ECE/TRANS/WP.29/GRE/2009/64 16 July 2009

REGULATION No. 48 (Installation of lighting and light-signalling devices)

Clarifications on installation requirements

Proposal for draft Supplement 5 to the 04 series of amendments to Regulation No. 48

Figure 1a: Rear

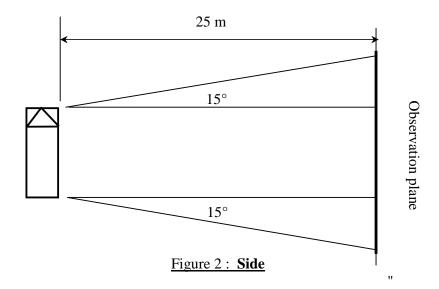
"6.21.5.1. for rear **and front** conspicuity markings (see Annex 11, Figures 1**a and 1b**) the observation plane is perpendicular to the longitudinal axis of the vehicle situated 25 m from the extreme end of the vehicle and bounded by:"

## Annex 11, amend to read:

"Annex 11
VISIBILITY OF CONSPICUITY MARKINGS TO THE REAR, FRONT AND SIDE OF A VEHICLE
